STOP LOVEMORE RANCH

APRIL 8, 2025

We request that you NOT approve the Project and NOT adopt the Mitigated Negative Declaration.

Re: PROJ-2021-00169 Tentative Tract Map 20443,
Assessor parcel no: 0602-361-04

Findings

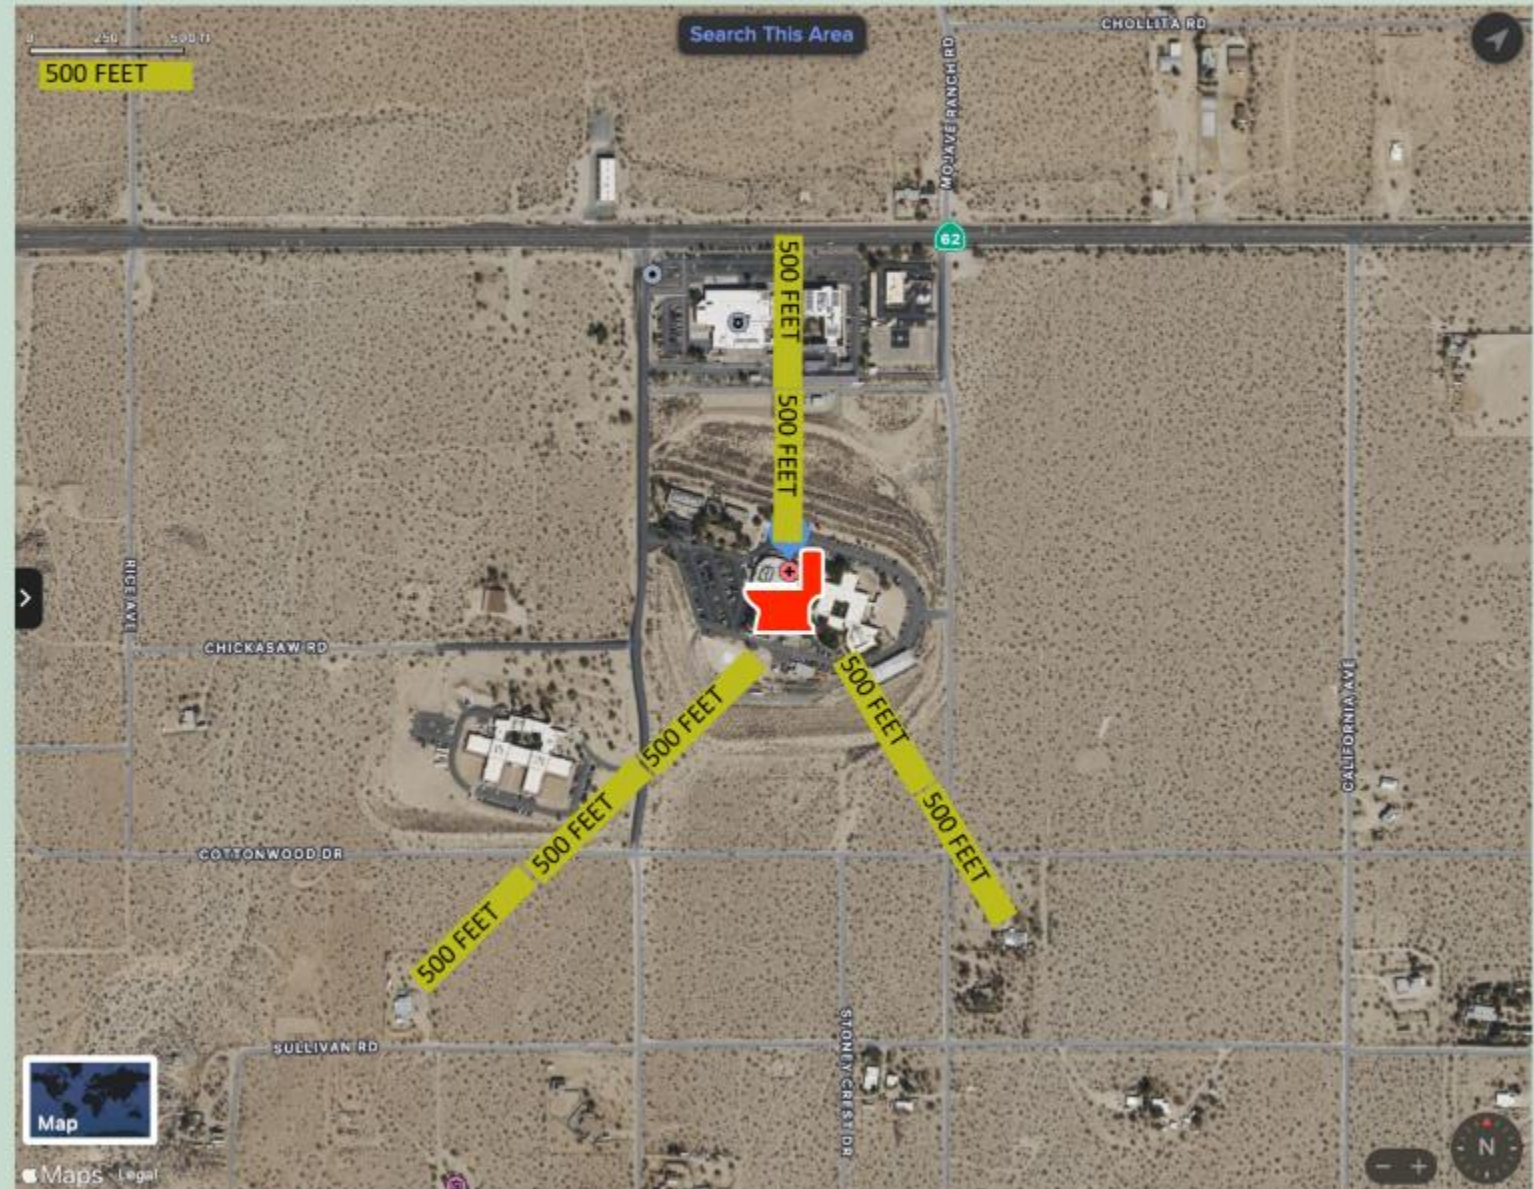
ANY TREATMENT FACILITY REQUIRES
JOSHUA TREE WATER BASIN APPROVAL
IN ORDER TO PROVIDE SERVICE.
NO EVIDENCE OF AGREEMENT PROVIDED

The proposed subdivision, its design, density and type of development and improvements conforms to the regulations of this Development Code and the regulations of any public agency having jurisdiction by law. **The proposed subdivision has the potential to produce 112 dwelling units; however, in consideration of the General Plan, Community Action Guide and Development Code, has applied to establish 64- dwelling units.** The proposal meets the minimum lot size, depth, width, and density requirements of the San Bernardino County Development Code. The proposed development has also been reviewed by the Regional Water Quality Control Board and has approved their wastewater treatment facility.
